State Significant Development Application - SSD 80626208

8-10 New McLean Street, Edgecliff

Figure 4.6: Proposed 1% AEP flood event depth map

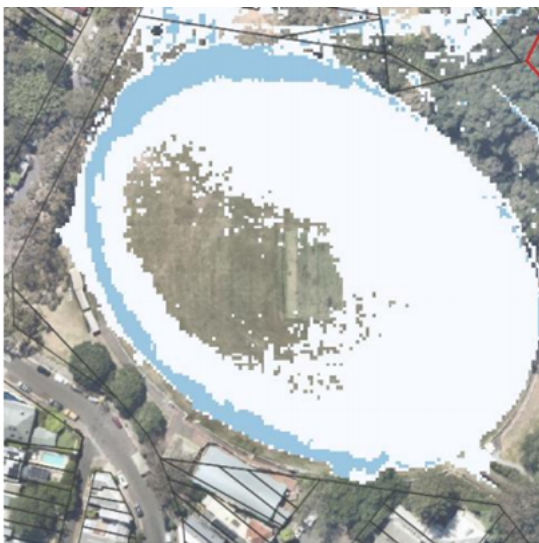
Review of Afflux (Figure 4.18): The main concern is that the categories in the legend require greater definition. For example, a range of 0m to 50mm is too crude if most Councils will not accept an increase of greater than 20mm. The modelling also indicates an increase of over 50mm in the 1% AEP. If all new developments in Sydney were approved with an increase of greater than 50mm there would be a significant increase in flood damages and the risk to life.

Comparison of Existing v Proposed 1% AEP Flood Depths: Figure 4.6 (Proposed) is incorrect as it shows that Trumper Oval now becomes largely flood free compared to Figure 3.12 (Existing).
